AMENDMENTS TO THE DRAWINGS

REMARKS

Fig. 1
PRIOR ART

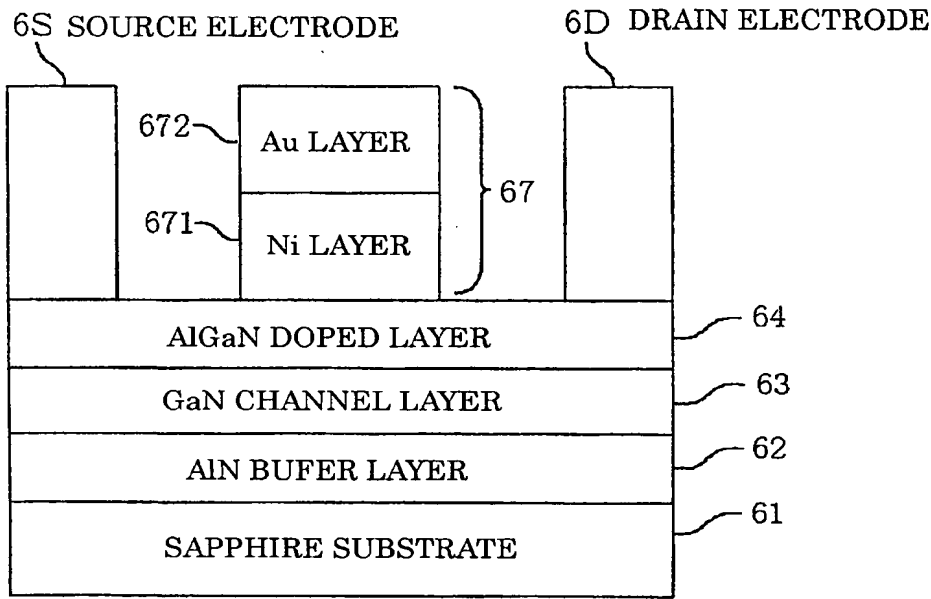
Please replace the formal drawing sheets currently on file with the replacement drawings sheets submitted herewith. The changes to the drawings are to label Figs. 1-4 as Prior Art and to add new Fig. 8 to show a feature required by the Examiner. No new matter is being added.

The drawings were objected to and the requirement was made to label Figures 1-4 as prior art. As shown above, new Figures 1-4 are submitted herewith to include the designation "Prior Art." The drawings were also objected to for not showing the first metal layer comprising NiN or PdN. In response, a new figure, Figure 8A, is added, together with appropriate additional text in the specification, to show this feature. No new matter has been added.
